**Priority Projects Standing Advisory Committee Report
Boroondara Planning Scheme
Referral 27: 442-450 Auburn Road and 9 Bills Street,
Hawthorn**

24 April 2023

Referral 27: 442-450 Auburn Road and 9 Bills Street, Hawthorn

Figure 2 Framework Plan in the consultation draft DPO4

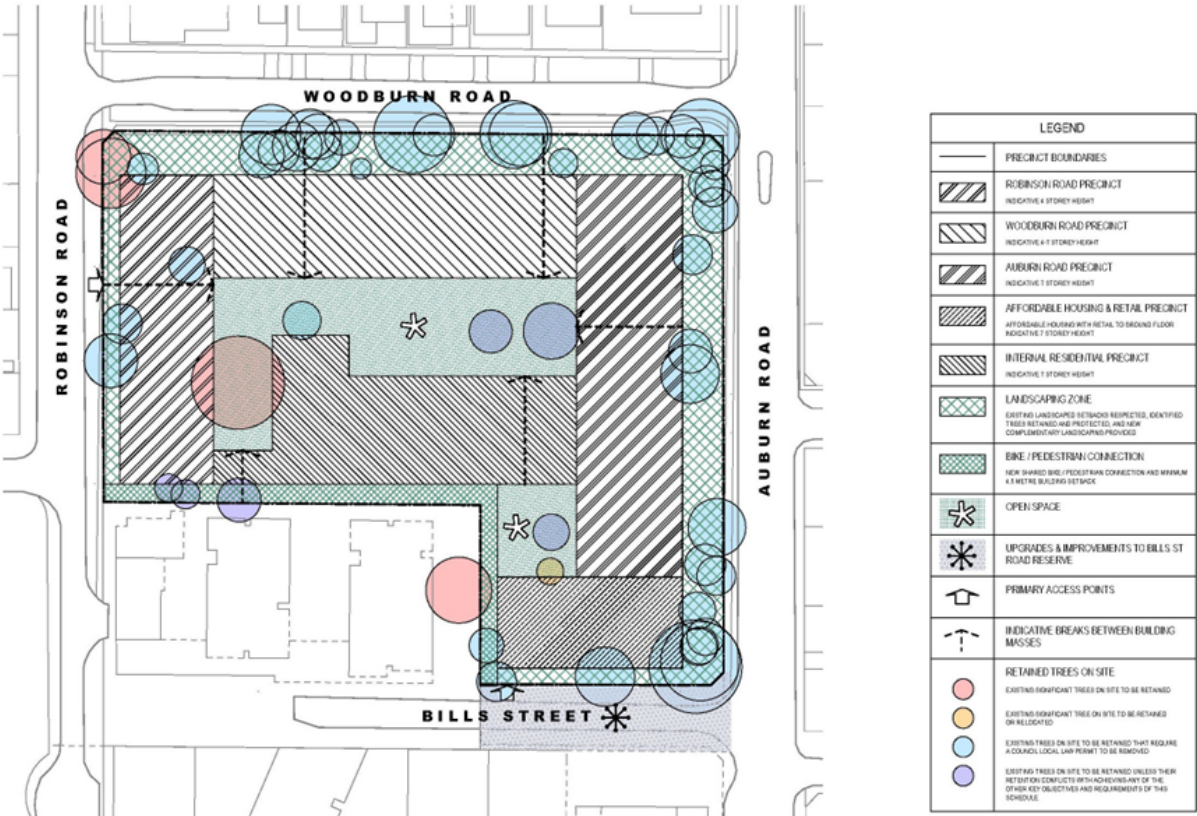
The consultation draft Framework Plan (Figure 2) shows:

The draft Development Plan shows in the order of 4,900 square metres of publicly accessible open space (see Figure 8 below), whereas the DPO4 refers to “*publicly accessible open space of at least 2,000 square metres in size generally in accordance with the location shown in Figure 1*” (see Figure 2 above).

Figure 3 Framework Plan in the Proponent’s revised DPO4

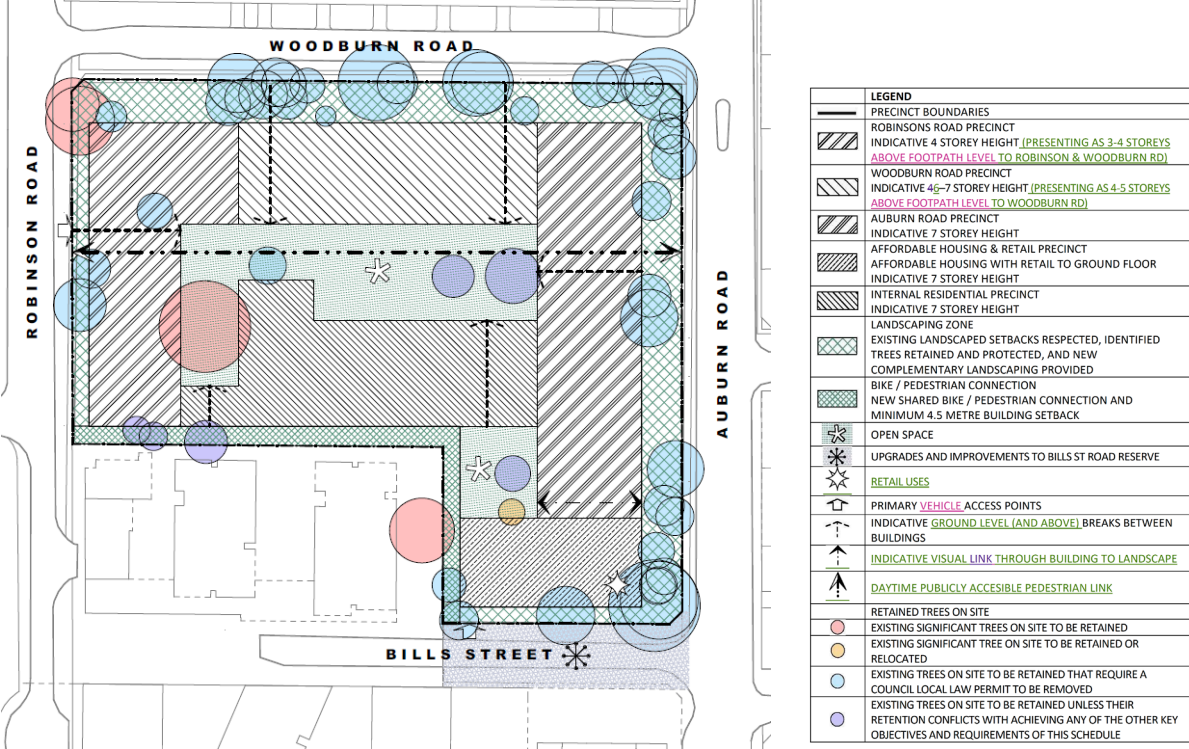
The Proponent's revised Framework Plan (Figure 3) shows:

The revised Framework Plan also extends the Robinson Road Precinct extended further around the corner into Woodburn Road (see Figure 3).

5. Amend the Framework Plan as shown in Appendix E:

BILLS STREET PRECINCT
MAXIMUM 7 STOREYS WITH RETAIL TO GROUND FLOOR
- In the legend, change the description of the bike/pedestrian connection to:

INDICATIVE ALIGNMENT OF NEW SHARED BIKE / PEDESTRIAN CONNECTION AND MINIMUM 4.5 METRE BUILDING SETBACK (24 HOUR PUBLIC ACCESS)
- In the legend, change the description of the Open Space to:

Figure 6 Housing Framework Plan at Clause 02.04

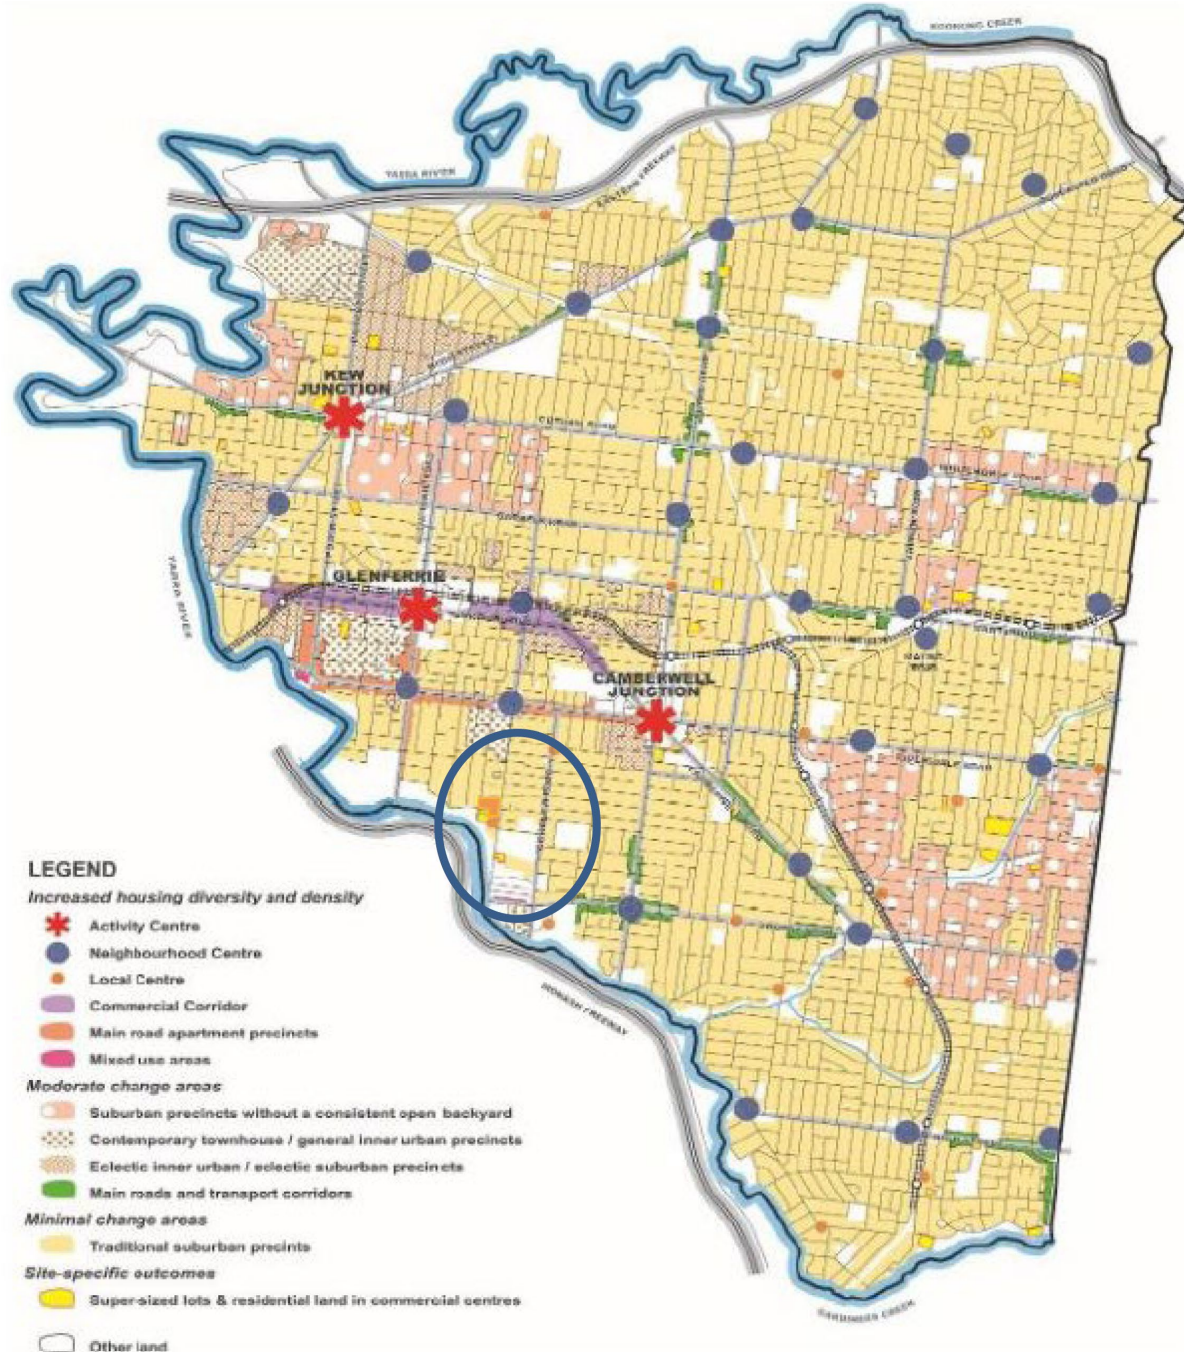
The Housing Framework Plan in Council's Municipal Planning Strategy² identifies the subject land as 'other land', reflecting its current non-residential use (shown as  on Figure 6). The surrounding area is a minimal change area.

- b) Update the Housing Framework Plan in Clause 02.04-3 of the Planning Scheme to identify the subject land as 'Main road apartment precincts'.**

Figure 7 Heights and setbacks shown in the draft Development Plan

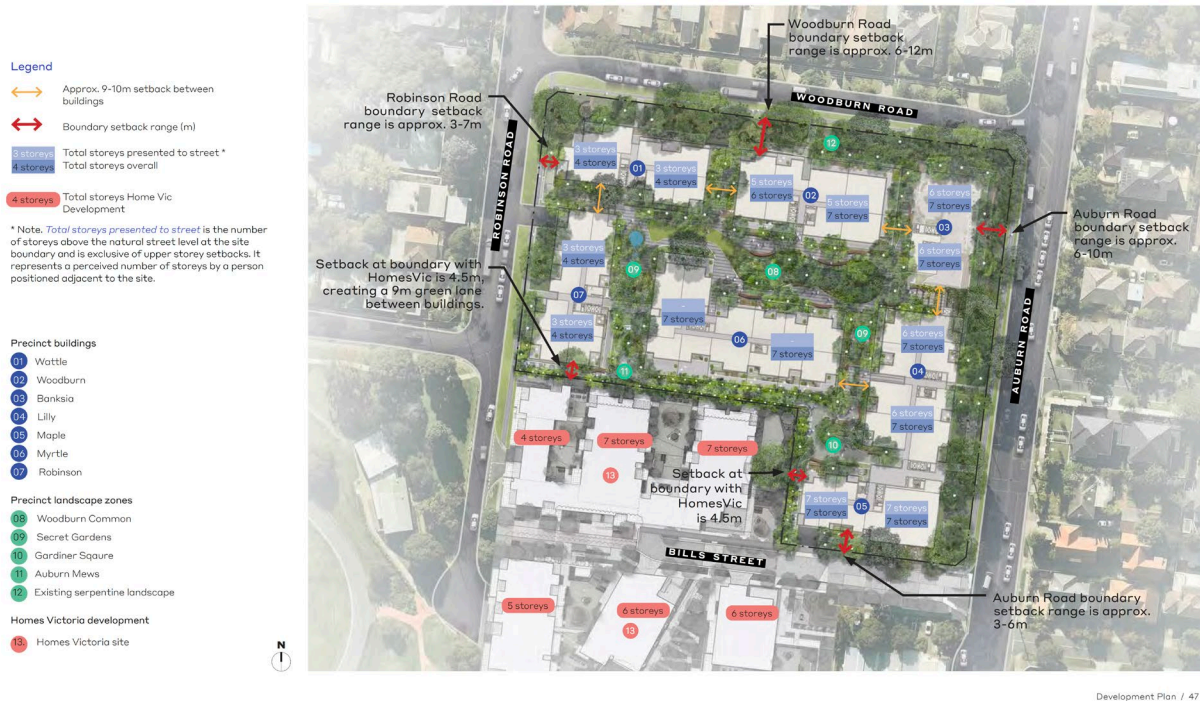
The draft Development Plan showed building envelopes with heights in storeys and dimensioned setbacks (see Figure 7). It contemplated lower heights ‘presented to street’ (except along the southern boundary), with a higher overall height set back from the street.

Professor McGauran considered that visual links through the subject land are important, as shown on the draft Development Plan with the 'campus style' building placement (Figure 7). He supported the nominated breaks between buildings shown in DPO4 Framework Plan and considered it particularly important to break up building form along the streetscape, especially Woodburn and Robinson Roads, both at ground level and above, as well as providing visual links between buildings into the open spaces in the interior of the subject land.

Ms Proposch submitted that the Framework Plan needs to clearly show block buildings and a pavilion approach with building breaks (like the draft Development Plan – refer to Figure 7, page 28), rather than a continuous line of built form.

Figure 9 Mr Sheppard’s recommended Framework Plan

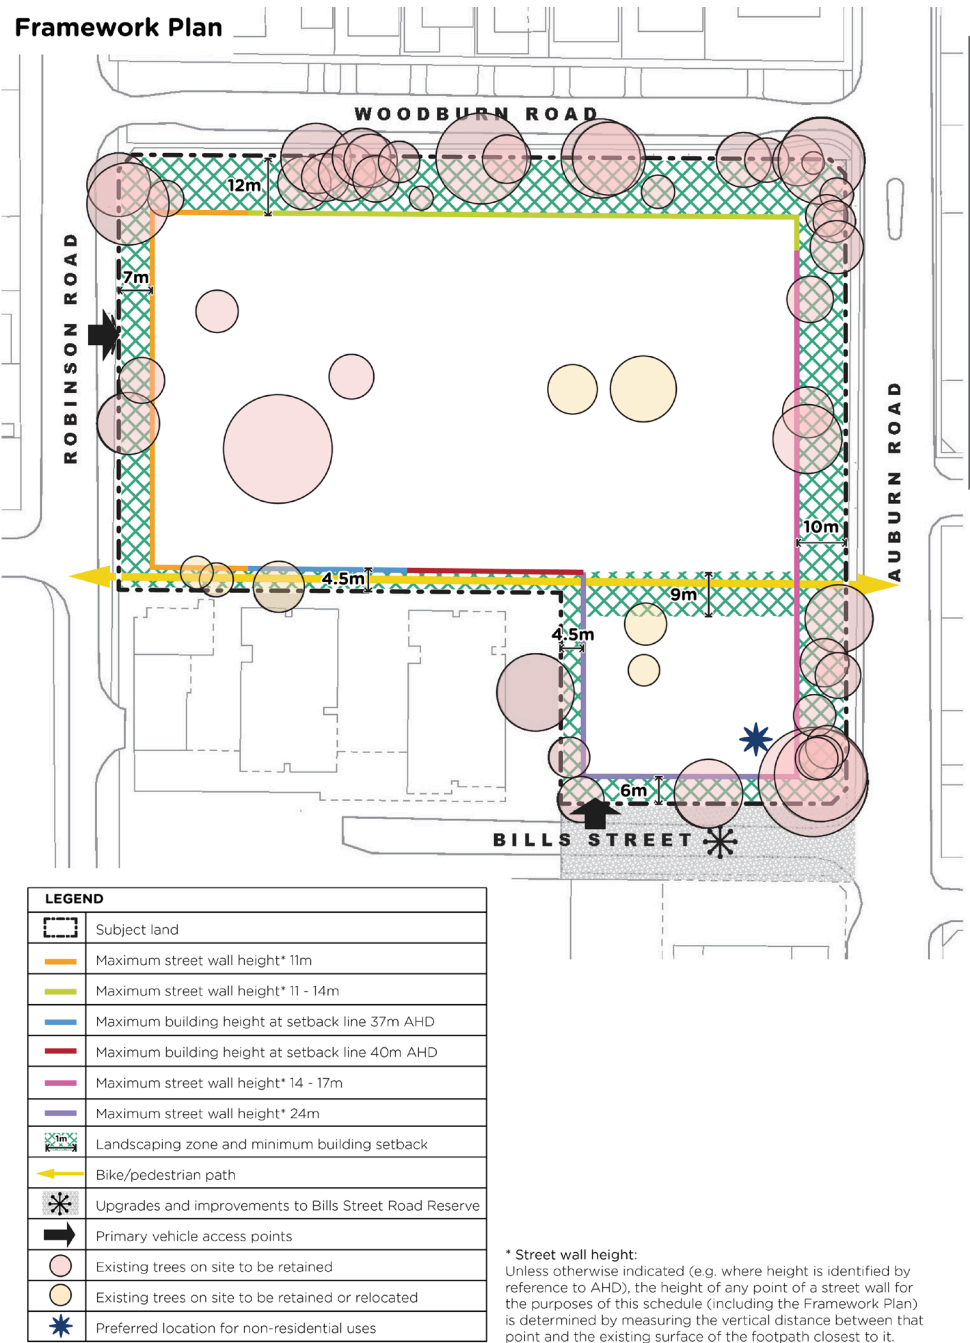
Mr Sheppard considered the Framework Plan could be less prescriptive about where these building breaks should be, and submitted an alternative Framework Plan (Document 12, extracted in Figure 9 on page 58 of this Report) which showed maximum street wall heights and setback dimensions but no detail regarding the internal arrangement of development on the subject land, including the location of breaks between buildings.

development plan and in the final design. His recommended Framework Plan is extracted in Figure 9 below.

Mr Sheppard's more 'minimalist' approach was not supported by the Proponent or its witnesses. The Proponent submitted that the more detailed Framework Plan in its revised DPO4 provided more helpful guidance to future decision makers. It queried whether Mr Sheppard's Framework Plan is *"consistent with the expressed desire of the community and the Council for transparency and certainty in terms of future outcomes on this land"*.

On balance, the Committee considers the Framework Plan should contain more detail than that recommended by Mr Sheppard, notwithstanding that it would be accompanied by (and read and interpreted with) the text of the DPO4. While the Committee supports maintaining flexibility in the DPO4 to allow for innovative design approaches, this must be balanced against providing the community (and Council) with some degree of certainty as to the general layout and scale of the future development on the subject land. Where it considers more flexibility is required (for instance, in the location of the open space), the Committee has recommended additional wording in the DPO4 in Appendix E.

Figure 1 – Framework Plan **2022**

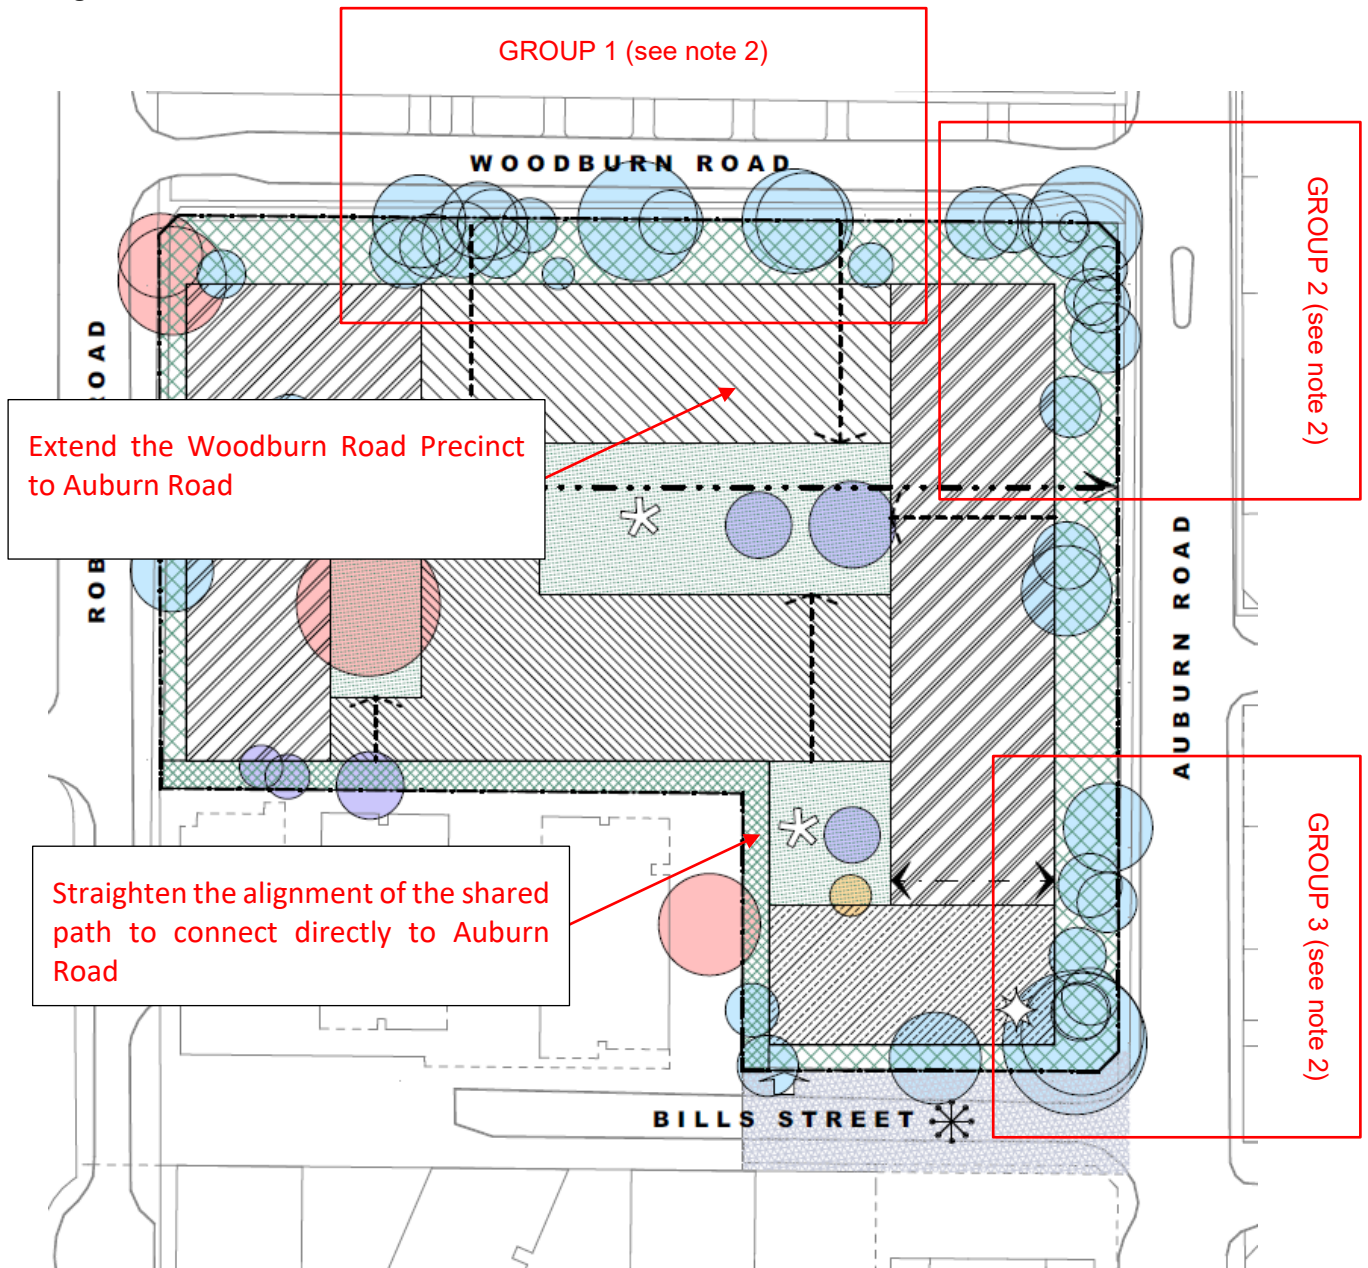
All building heights ~~are to~~ should be generally in accordance with the maximum ~~indicative~~ building heights shown in *Figure 1*.

Buildings ~~are to~~ should be set back to facilitate the retention of the Paul Thomson designed serpentine landscape along Woodburn Road and ~~identified~~ existing canopy trees on the land identified for retention in, ~~generally in accordance with~~ *Figure 1*.

Ground level ~~(and above)~~ landscaped breaks of at least 9 metres in width ~~are to~~ should be provided between new buildings, generally in accordance with the locations shown in *Figure 1*. The landscaped breaks should be open to the sky.

Visual links ~~should be provided~~ through new buildings to landscaped spaces ~~are to be provided~~, generally in ~~accordance with~~ the locations shown in *Figure 1*.

~~The edges of the buildings, building heights and setback envelopes shown in Figure 1 are indicative only. Minor variations, other than to dimensioned setbacks, resulting from the detailed design may be acceptable provided the objectives of Clause 1.0 are met, to the satisfaction of the responsible authority.~~

10% of all new dwellings provided on the land ~~are to~~ should be provided as Affordable Housing, as defined in the *Planning and Environment Act 1987*, ~~in the location prescribed in Figure 1~~, to the satisfaction of the responsible authority.
